## February 2023 Bulli community information and feedback session

### Feedback summary

This document summarises the feedback themes Landcom heard about draft design concepts for new housing on the former Bulli Hospital site, which we sought community comment on during February 2023 as part of the concept planning process.

# Concept A

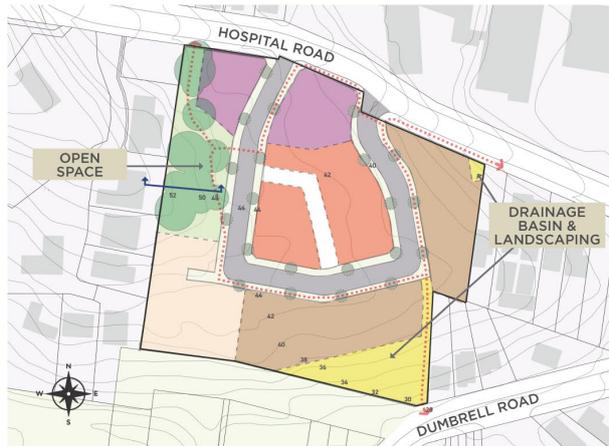
|   | Comments about draft design concepts  |
|---|---|
| <p><b>Concept A – refer to Appendix A</b></p> | <ul style="list-style-type: none"> <li>• Support for:               <ul style="list-style-type: none"> <li>- mix of housing types</li> <li>- number of dwellings, for reasons including fewer vehicles and fewer future residents (compared to other concepts), which one respondent considered more attractive for the area</li> <li>- balance of open space and dwellings</li> <li>- amount and location of open space</li> <li>- proposed internal street layout</li> <li>- location of through-site pedestrian and cycling connections</li> <li>- number of freestanding homes, to limit ‘overcrowding’</li> <li>- drainage solutions to reduce impact of stormwater run-off and flooding</li> </ul> </li> <li>• Suggestions to consider:               <ul style="list-style-type: none"> <li>- fewer dwellings, reduce building footprint to allow for more green space</li> <li>- limit dwelling heights to one storey</li> <li>- more green space, including along Hospital Road to boost street appeal</li> <li>- retain natural environment, including trees along Hospital Road frontage, and increase green corridors for local wildlife</li> <li>- deliver enough parking for future residents and visitors, and hospital staff to minimise overflow parking on Hospital Road</li> <li>- two car spaces per dwelling, underground resident parking</li> <li>- design of site access from Hospital Road, including one entry/exit to Hospital Road</li> <li>- make internal loop street one-way to enable more street parking</li> <li>- road connection between Hospital Road and Dumbrell Road to help with traffic flow, access for ambulances</li> <li>- ensure the manor home driveways fronting Hospital Road do not impact potential additional parking on Hospital Road</li> <li>- drainage solutions to reduce impact of stormwater run-off and flooding</li> <li>- restore former hospital buildings for community use and historic value</li> <li>- incorporate design elements of Concept C, including the proposed internal street layout, greater amount of green space, through-site pedestrian connections</li> </ul> </li> </ul> |

# Concept B

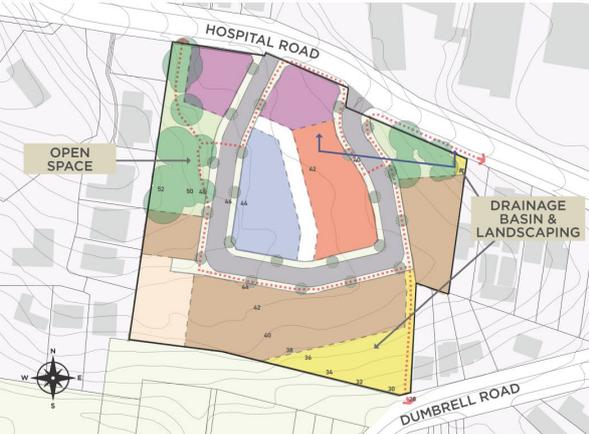
|   | Comments about draft design concepts  |
|---|---|
| <p><b>Concept B – refer to Appendix A</b></p> | <ul style="list-style-type: none"> <li>• Support for:               <ul style="list-style-type: none"> <li>- mix of housing types</li> <li>- number of dwellings</li> <li>- amount of open space, two open spaces</li> <li>- trees being retained, supporting wildlife</li> <li>- proposed internal street layout and location, including the two entrances to the site</li> </ul> </li> <li>• Suggestions to consider:               <ul style="list-style-type: none"> <li>- retain trees along Hospital Road frontage</li> </ul> </li> </ul>   |

| Comments about draft design concepts   |  |
|--|--|
|  | <ul style="list-style-type: none"> <li>- maximise the number of parking spaces per dwelling</li> <li>- make internal loop street one-way to enable more street parking</li> <li>- drainage solutions to reduce impact of stormwater run-off and flooding</li> <li>- discuss boundary fence height with neighbours</li> </ul>   |

# Concept C

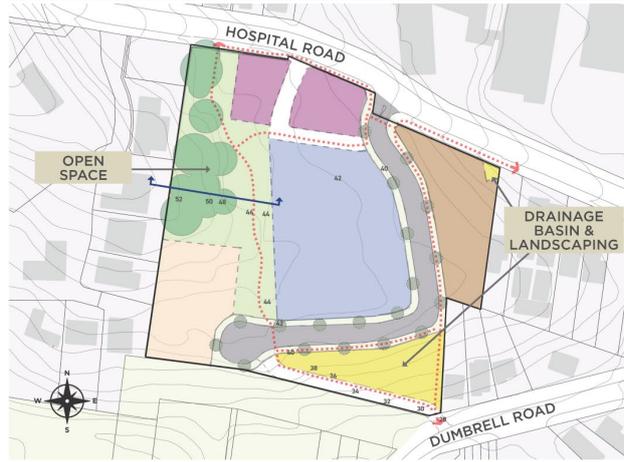
| Comments about draft design concepts   |  |
|--|--|
| <b>Concept C – refer to Appendix A</b> | <ul style="list-style-type: none"> <li>• Support for: <ul style="list-style-type: none"> <li>- mix of housing types, including low-rise apartments to provide more affordable options</li> <li>- number of dwellings, to provide more housing</li> <li>- development concentrated in one area to allow for more open space</li> <li>- higher density being delivered on a site away from the beach</li> <li>- amount of open space relative to other concepts</li> <li>- retention of trees, including the mature Turpentine on the western side of the site, to provide habitat for wildlife</li> <li>- proposed internal street layout and location</li> <li>- drainage solutions to reduce impact of stormwater run-off and flooding</li> </ul> </li> <li>• Suggestions to consider: <ul style="list-style-type: none"> <li>- limit number of dwellings to 50</li> <li>- reduce building heights. One respondent considered 12 metres to be excessive</li> <li>- no low-rise apartments. Some respondents considered these to be out of character with the area, one was concerned about it looking like a ‘ghetto’</li> <li>- retain open space and trees in northeast corner of the site</li> <li>- deliver enough parking for future residents and visitors, and hospital staff to minimise overflow parking on Hospital Road</li> <li>- extra traffic turning right onto Hospital Road</li> <li>- re-use building materials or design features of former hospital to provide visual connection to site’s former uses</li> <li>- provision for a café within one of the buildings</li> </ul> </li> </ul> |

# Concept A

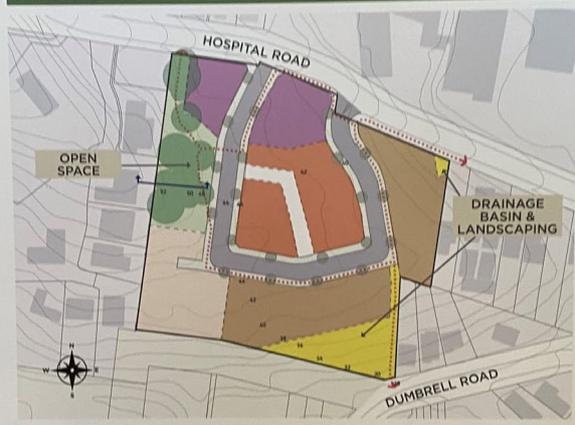
- Internal roads - one way
- Like the open space design

- I like this option, however more green space fronting Hospital Rd
- Increase green pathways (concrete) for ground dwelling + flying animals
- Prefer this option
- Shared zone on Hospital Rd?
- Consider traffic? one way internal reduced speed on Hospital Rd.
- Maintain the trees on the hospital road area.
